ADDENDUM TO REQUEST FOR QUOTATIONS (RFQ)

Solicitation	Mukilteo Library Meeting Room Water Damage Repair RFQ 2025.01.06
Date	January 17, 2025
Addendum #	2
Purpose of Addendum	Posting bidder questions and answers from mandatory walkthrough meetings on 1/13/2025 and 1/14/2025.

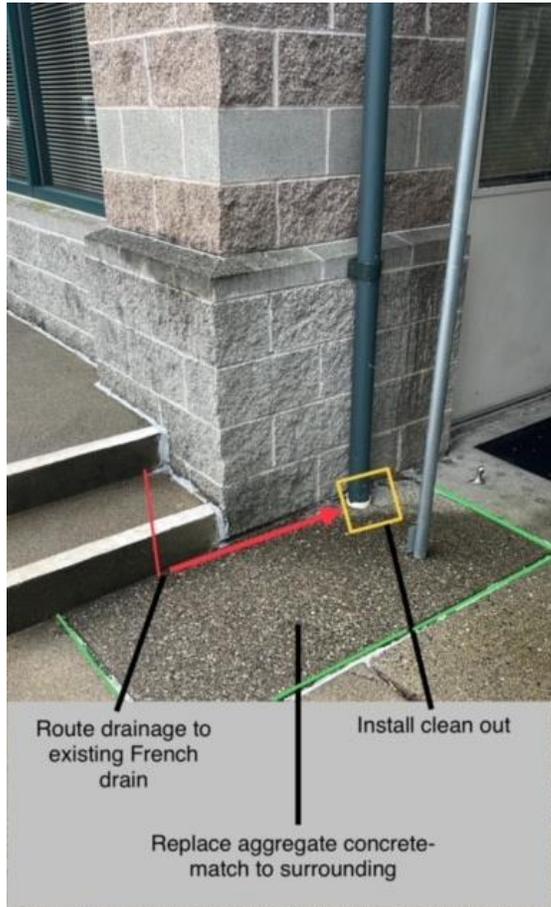
12. Are we only removing drywall in the two localized areas?

Contractor to remove the drywall surrounding the entirety of the window, from the floor up to the mechanical soffit and out approximately three feet beyond the window to ensure no additional rot is found in adjacent wall area.
